Palo Verde Nuclear Generating Station Unit 3

Core Operating Limits Report, Revision 26

PVNGS Unit 3 Core Operating Limits Report Revision 26

Revision 26

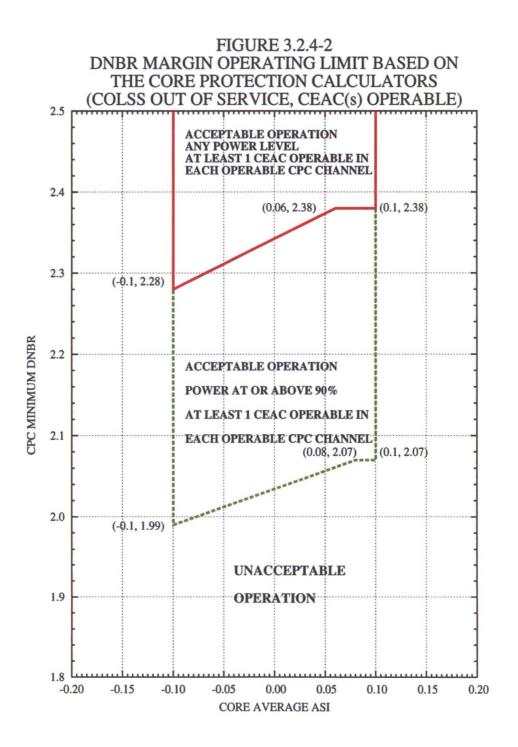
Pursuant to Palo Verde Nuclear Generating Station (PVNGS) Technical Specifications, Section 5.6.5.d, enclosed is the Unit 3 Core Operating Limits Report, Revision 26, which was made effective October 23, 2019. Figure 3.2.4-2 was updated in this revision. A revision bar has been applied to the change.

COLSS OUT OF SERVICE and CEAC(s) OPERABLE - Operate within the region of acceptable operation of Figure 3.2.4-2 using any operable CPC channel.
